Tweed Valley Hospital Stage 2 Modification 5

Minor Changes to Multi-Deck Carpark
State Significant Development Modification Assessment
(SSD-10353-Mod-5)

October 2022

Figure 3 | Approved and proposed south elevations (Source: Modification Report)

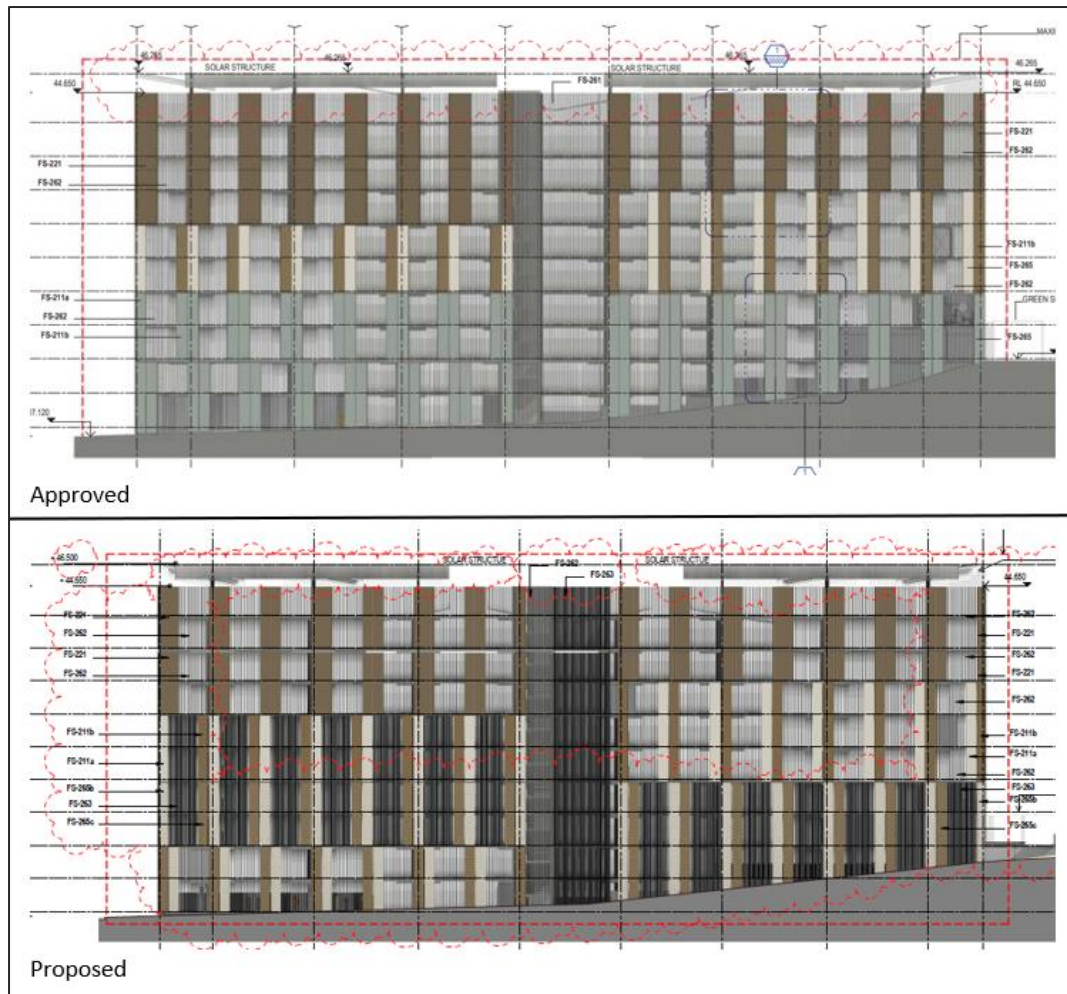
Subsequent to the previous approval for multi-deck carpark façade amendments under Modification 3 (SSD-10353-Mod-3), Fire and Rescue NSW (FRNSW) noted that the fire performance solution for the carpark is heavily reliant on the natural ventilation provided by the open-deck nature of the structure. FRNSW requested that the Applicant quantitatively demonstrate that the building will provide/maintain safe occupant egress provisions at all times given a worst-case credible fire scenario.

In order to address the concerns raised by FRNSW, the modification proposes to increase the perforation of the multi-storey carpark façade to provide for open air above the minimum BCA requirement. Therefore, the proposed façade will be 73 per cent open on the Ground Floor and Level 1, and 55 per cent at Levels 2 to 5. In response to this, the proposal also includes minor amendments to the size and colour composition of the façade.

The Applicant has provided a Fire Engineering Report which takes into consideration fire safety and BCA requirements. The report concludes that the proposed design would achieve compliance with the BCA.

The Department raises no concerns with the proposed amendments to the façade, noting that it would not detract from the overall visual amenity of the structure, and that the appearance of the structure would appear largely unaltered in sightlines from outside the hospital site.

Figure 5 | Approved and proposed lower ground floorplan (café, north-east corner) (Source: Modification Report)

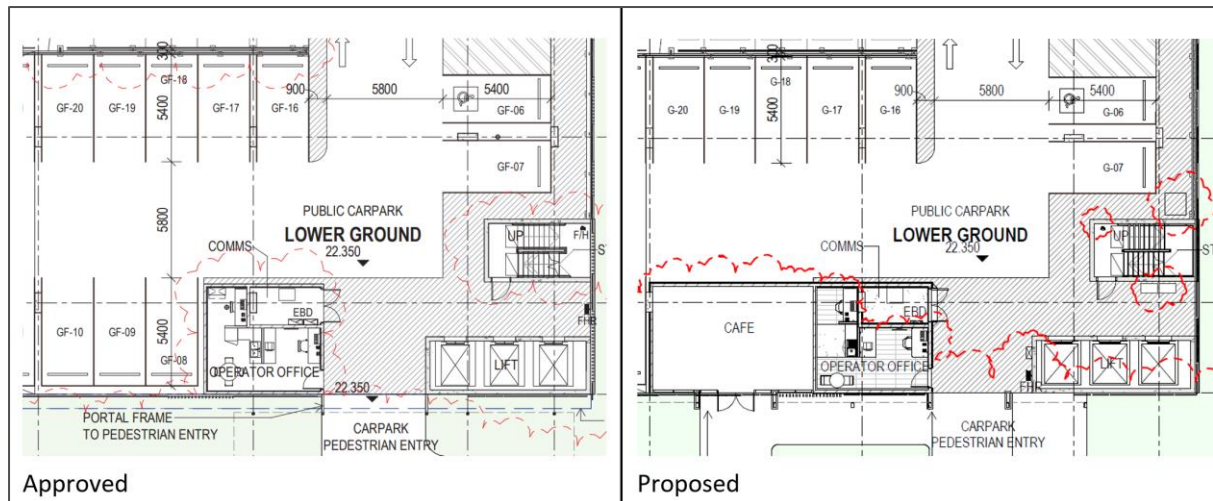
To accommodate the proposed provision of the ground floor café unit, three car parking spaces would be lost. Four parking spaces at Level 3 would also be lost following the relocation of the staff overflow boom gates, with two parking spaces reinstated at Level 4. Overall, there would be a net loss of five parking spaces, resulting in a total provision of 1,203 parking spaces across the hospital campus.

Council raised no concerns regarding the loss of the five parking spaces. However, it noted that a café of this size would employ two staff, and therefore would require two additional parking spaces based on Council's DCPA2 (Site Access & Parking Code). Accordingly, Council requested that condition B30(a) be revised to require a minimum of 1,203 on-site car parking spaces. The Applicant also requested that condition B30(a) be revised to take into consideration the provision of short-term parking spaces within the campus.

The Department is satisfied that, following the proposed amendments, appropriate car parking provision would be retained across the hospital campus. Council's request for the provision of two additional minimum parking spaces to accommodate café staff is also agreed. Overall, the on-site parking provision of 1,203 spaces would meet the minimum requirement resulting from the proposed modification. It is therefore recommended that condition B30(a) be revised to state:

- (a) a minimum of ~~1201~~ 1203 on-site car parking spaces (~~within~~ inclusive of the multi-deck carpark, ~~and the~~ at grade car park and short-term parking spaces) are provided on the Site.

Figure 7 | Proposed rooftop solar arrays (Source: Modification Report)

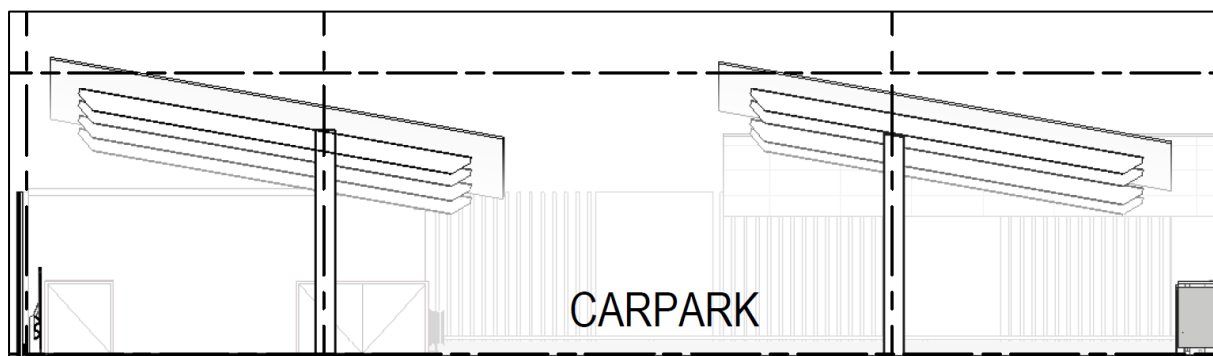
The proposed amendments to the height of the lift overrun (+0.2m) and to the orientation and pitch/height of the rooftop solar arrays (+0.35m) are minor in nature. The Department is satisfied that these alterations would not detract from the overall design and appearance of the multi-deck carpark structure. The proposed café entrance at ground floor (see **Figure 6**) would also have a minimal visual impact. The Department welcomes the inclusion of the café, noting that it would increase street activation at this location.

Issue	Findings	Recommendations
Reflectivity	Given that the solar PV panels are manufactured to absorb light rather than to reflect it, the change in pitch and arrangement is not expected to result in an adverse reflectivity impact.	No additional conditions are recommended.
Bicycle parking	The proposal includes the provision of e-bike charging facilities. The number of bicycle parking spaces within the multi-deck carpark (52) would remain unchanged. The Department welcomes the provision of e-bike charging facilities and supports the amendment.	No additional conditions are recommended.
Amenity	The Department is satisfied that the increase in height of the lift overrun and solar PV panels would be minor, and would not cause harm to the environmental amenity experienced at neighbouring receivers. The proposed amendments would not materially alter the level or duration of construction noise generated by the development.	No additional conditions are recommended.
